Report No. EGG-EA-5323

Adequacy of Station Electric Distribution System Voltages, Quad Cities - Unit Nos. 1 and 2, Docket Nos. 50-254 and 50-265, TAC Nos. 12808 and 12809

ADEQUACY OF STATION ELECTRIC DISTRIBUTION SYSTEM VOLTAGES

QUAD CITIES - UNIT NOS. 1 AND 2

Figure 1
QUAD CITIES 1 & 2
Unit One Line Diagram

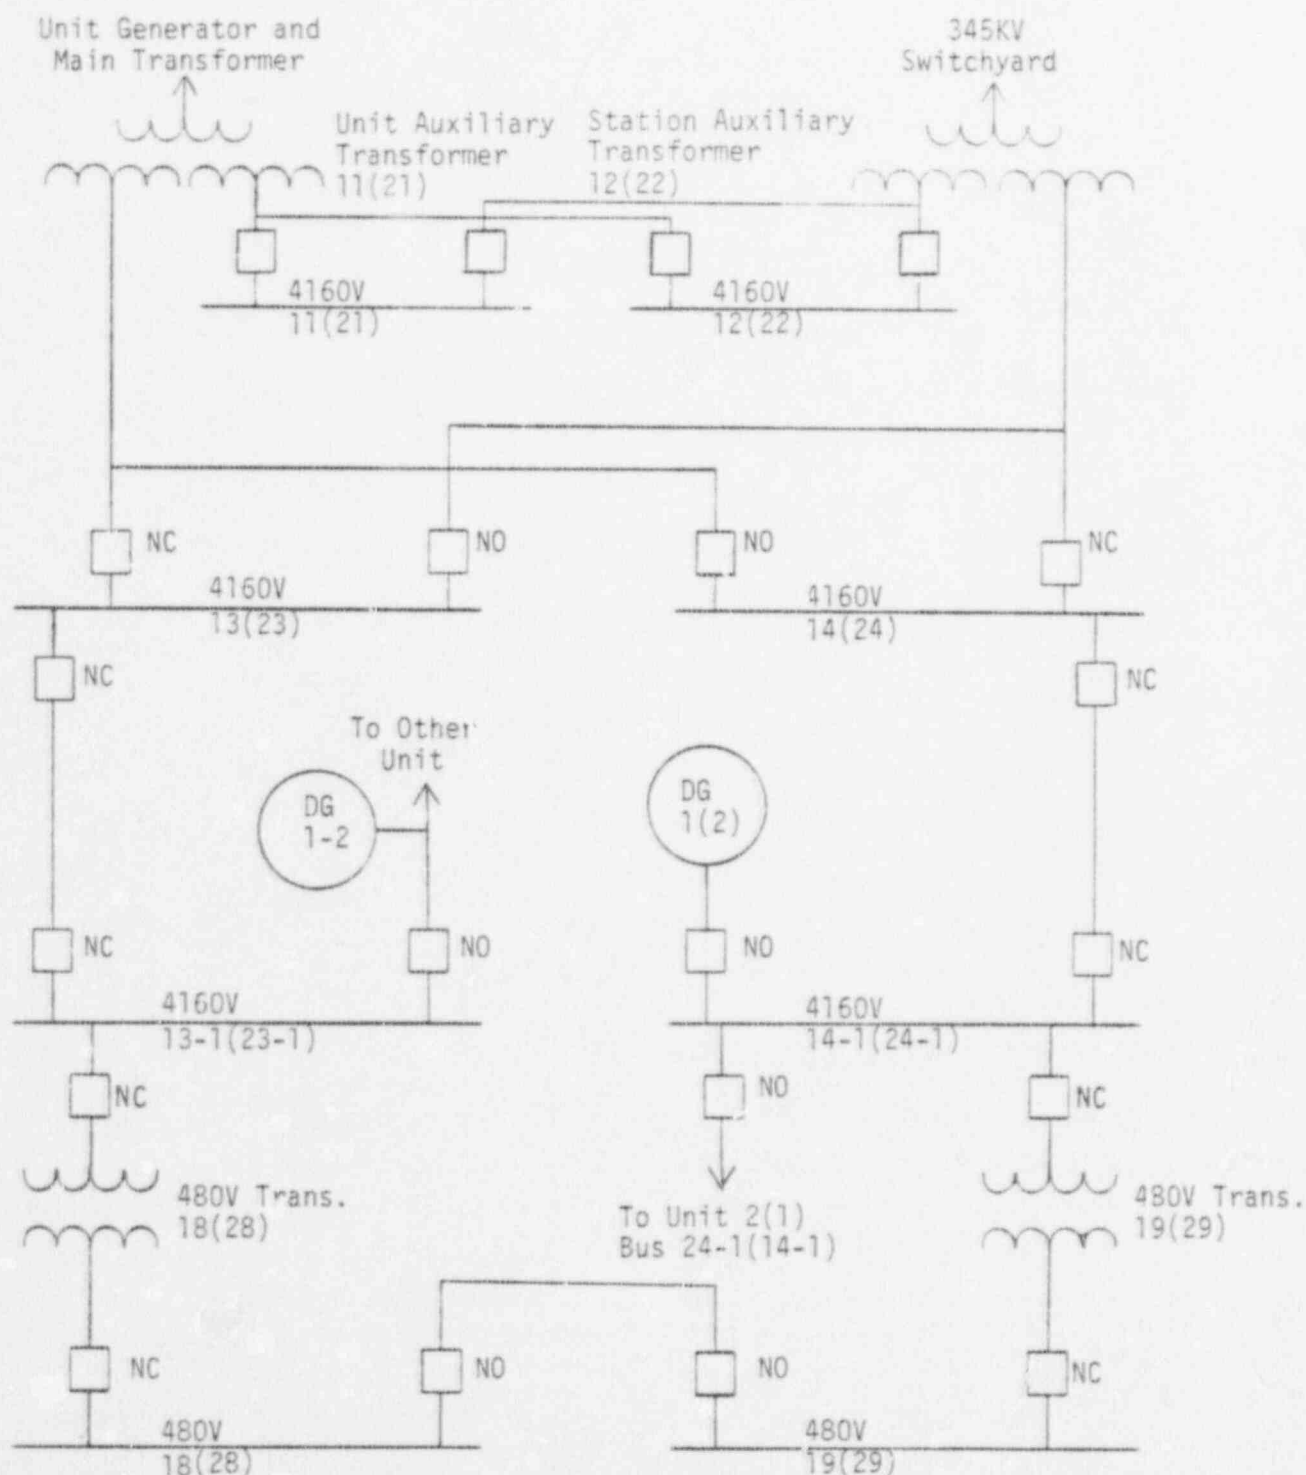
No technical specification restrictions have been identified on the connection between class 1E 480V buses 18 and 19 (28 and 29). CECo has not provided an analysis for use of this connection. Since the worst case 480V voltage without the connection is 90.5%, CECo should put appropriate restrictions on the use of this connection.

However, CECo should establish appropriate technical specification restrictions on connecting two class 1E 480V buses 18 and 19 or 28 and 29 together.
